LAND USE SERVICES DEPARTMENT
PLANNING COMMISSION STAFF REPORT

HEARING DATE: November 3, 2016 **AGENDA ITEM # 2**

Project Description: General Plan Renewable Energy and Conservation Element

Applicant:	Land Use Services Department
Community:	Countywide
Location:	Countywide
Staff:	Linda Mawby, Senior Planner
Proposal:	General Plan Amendment to incorporate a new Renewable Energy and Conservation Element.

Figure 1. Desert Linkage Network Conflicts

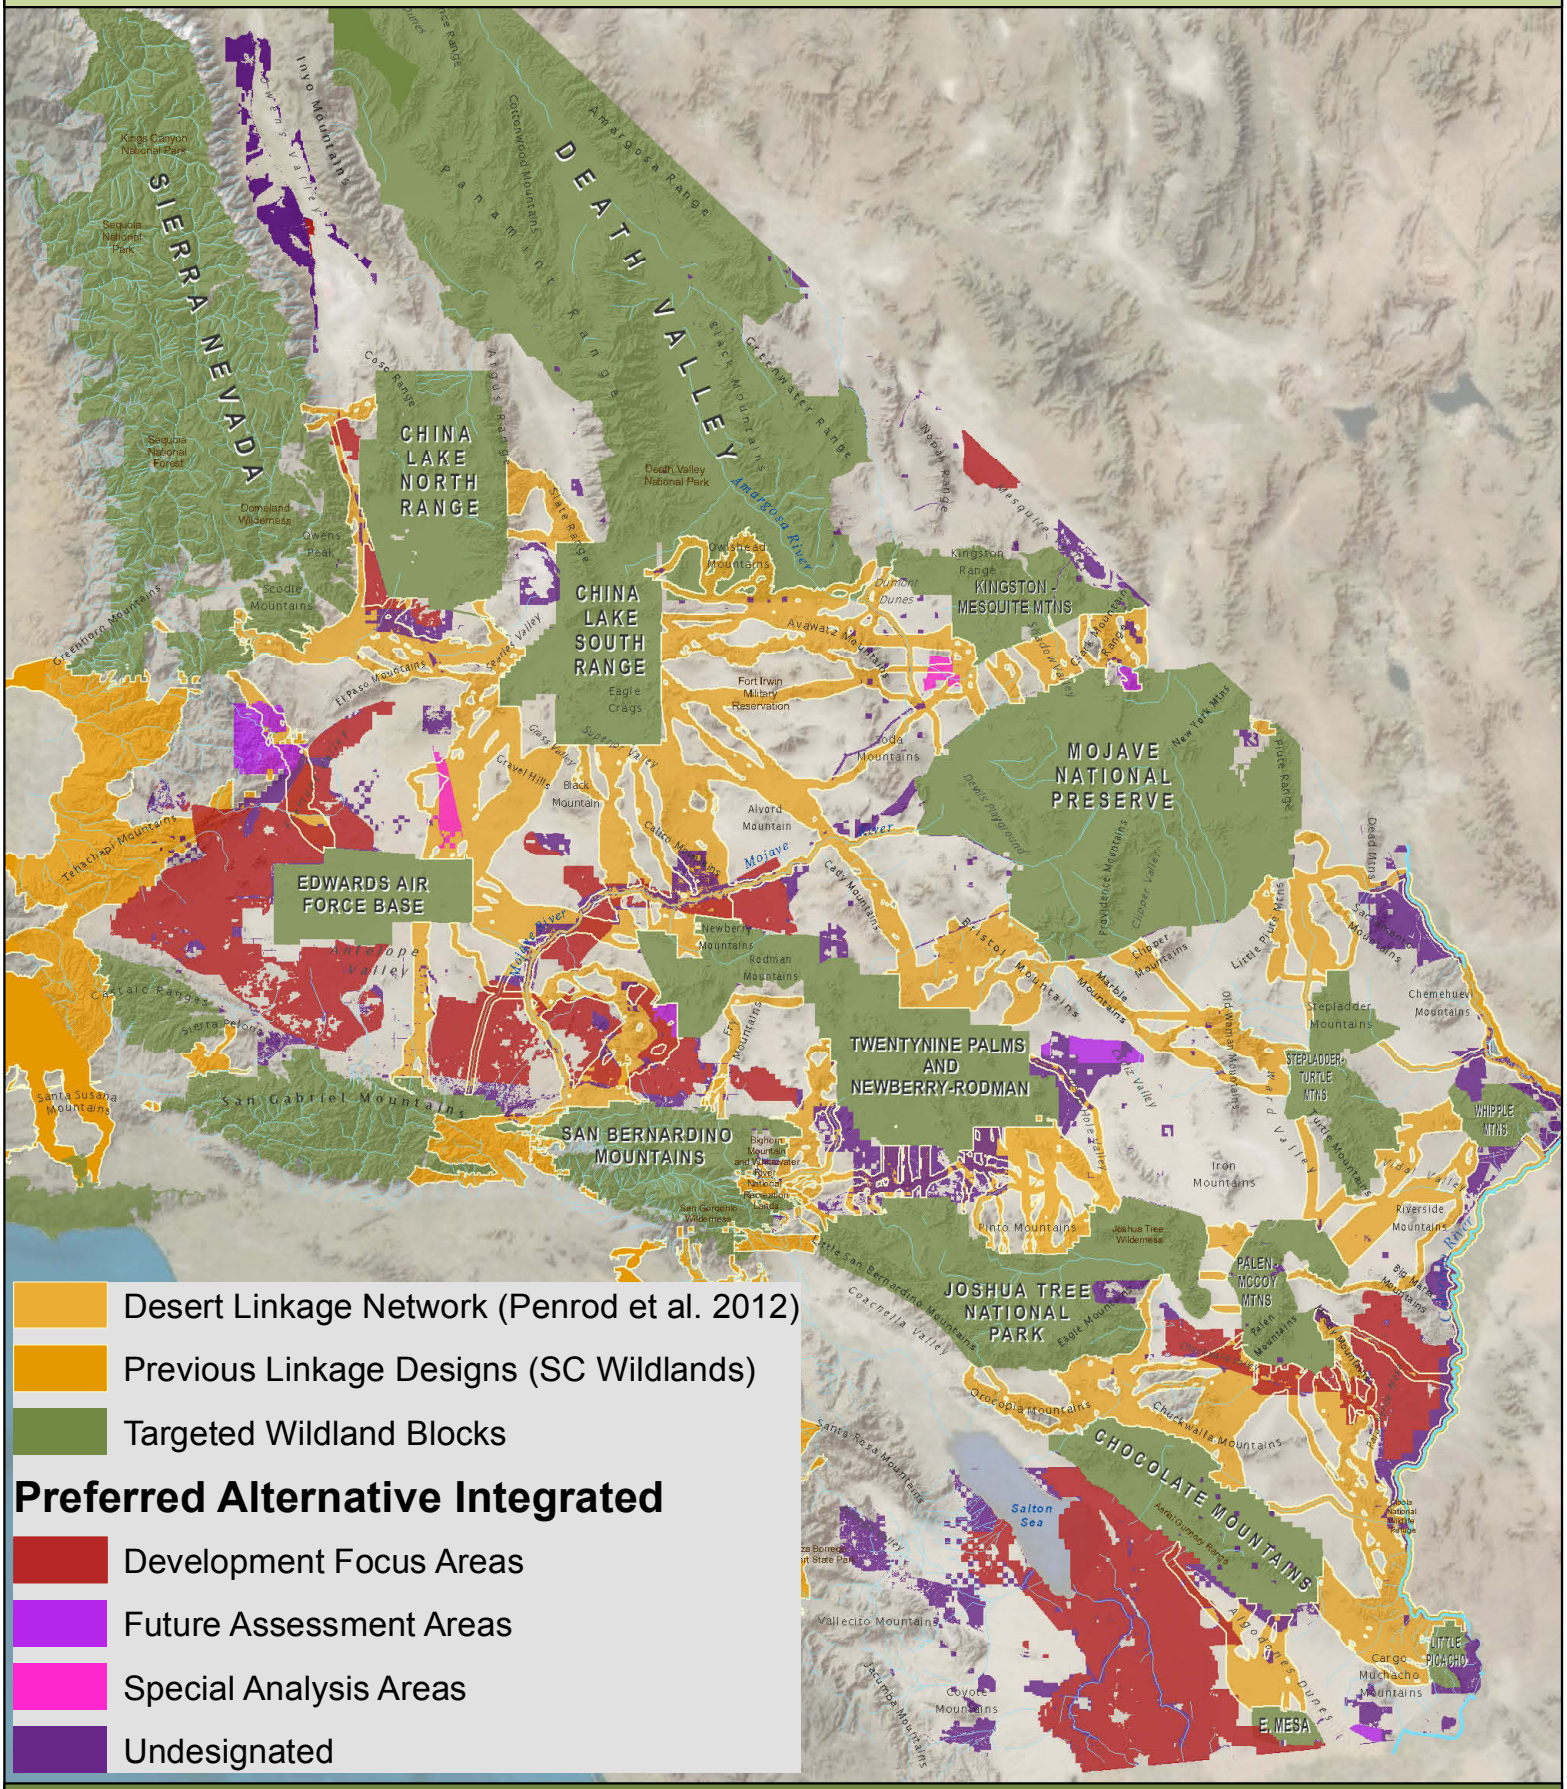
how the DFAs, FAAs, SAAs, Variance Lands, or Undesignated Lands in the Preferred Alternative coincide with the Desert Linkage Network, not to mention transmission corridors! Volume IV is the **Environmental Consequences / Affects Analysis** yet this section repeatedly refers to maps in Volume III, "Affected Environment Figures III.7-26 through III.7-36 in Chapter III.7 of Volume III shows the desert linkage network for the Plan Area and in each ecoregion subarea". Maps must be included in Vol. IV for the entire Desert Linkage Network and each of the six subareas that would be impacted. As Figure 1 shows, several linkages are completely severed or severely constrained by DFAs, FAAs and Undesignated land.

Figure 2. Coservation Values are High in the Pinto Lucerne Valley Eastern Slopes Ecoregion Subarea

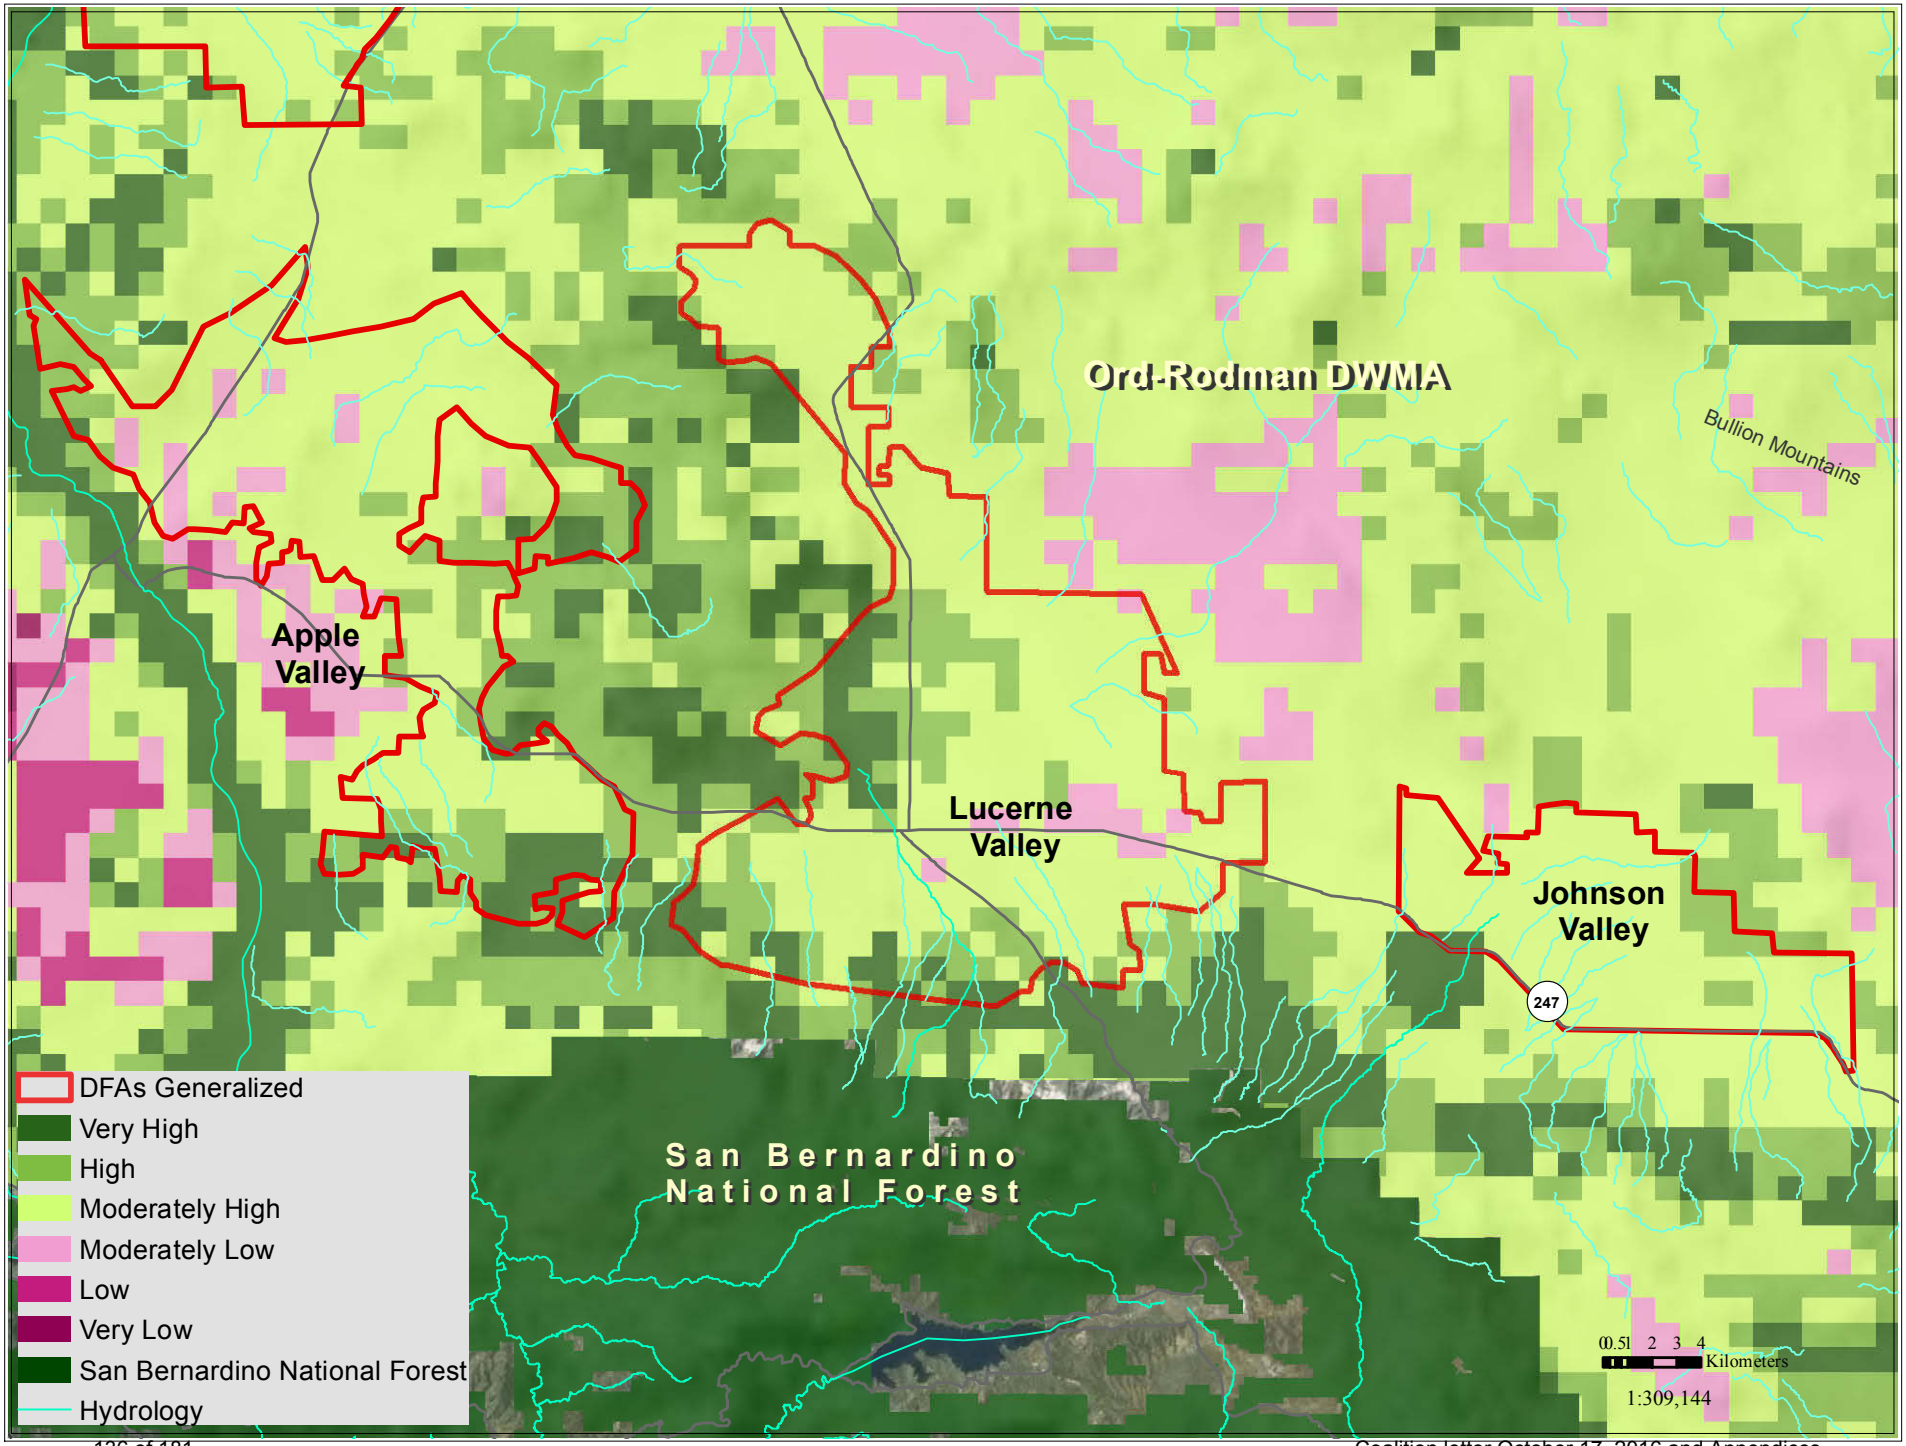
Conservation Values are particularly high in the Pinto Lucerne Valley and Eastern Slopes Subarea along the Mojave River, through the linkage, and all along the slopes of the San Bernardino Mountains (Figure 2). The Conservation Values Model available on the Data Basin Gateway aggregated several biological themes including natural community diversity, rare species concentrations, concentrations of Covered Species modeled distributions, concentrations of Non-Covered Species modeled distributions, and relative quality of identified wildlife linkages. Virtually all of the proposed Apple Valley, Lucerne Valley and Johnson Valley DFAs scored Moderately High to Very High with very few pixels scoring Moderately Low and no pixels scoring Low or Very Low. Section (II.3, Page 347), describes the Pinto Lucerne Valley and Eastern Slopes Subarea as, "some of the most diverse and threatened habitats in the California desert".

and San Gabriel Ranges. No DFAs should be sited within the 500 year flood plain and all Undesignated areas along the Mojave River should be included in the Reserve Design to ensure wildlife have access to this essential resource, which will be even more indispensible with climate change.

Figure 3. Refinements to and Removal of DFAs in the Pinto Lucerne Valley and Eastern Slopes Subarea

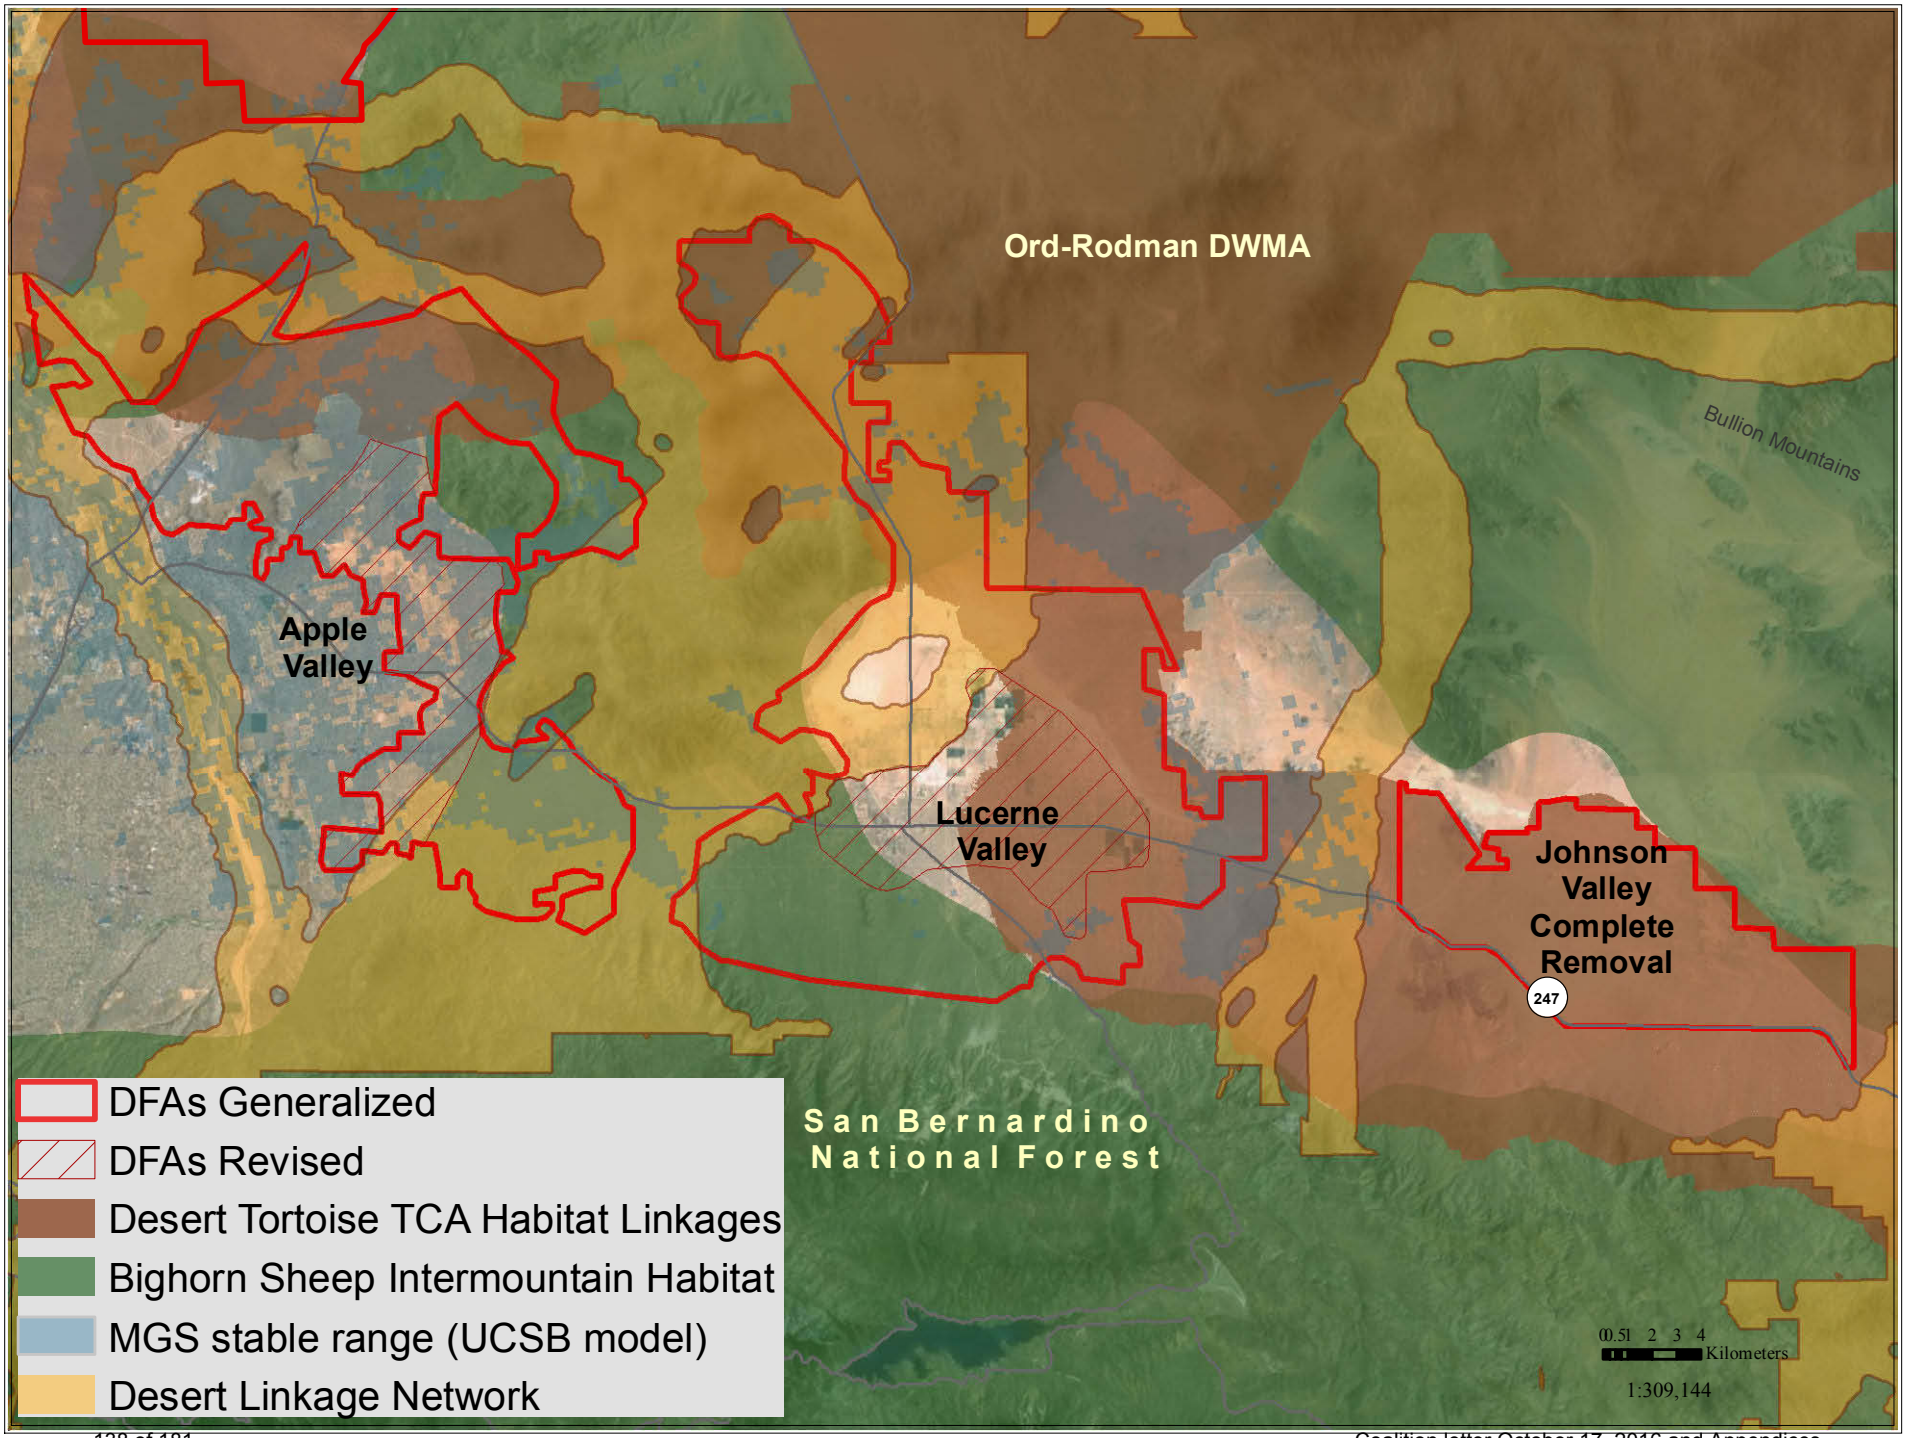
These refinements would benefit 18 of the Covered Species. According to the DRECP Composite Ecological Baseline, each pixel in the refinements to the Apple Valley DFA (573 pixels) benefit 4 to 11 Covered Species (MEAN 6.9 species), with a total species count of 3,959 in the 573 pixels. Each pixel in the refinements to the Lucerne Valley DFA (787 pixels) benefit 2 to 10 Covered Species (MEAN 6.45 species), with a total species count of 5,080 in the 787
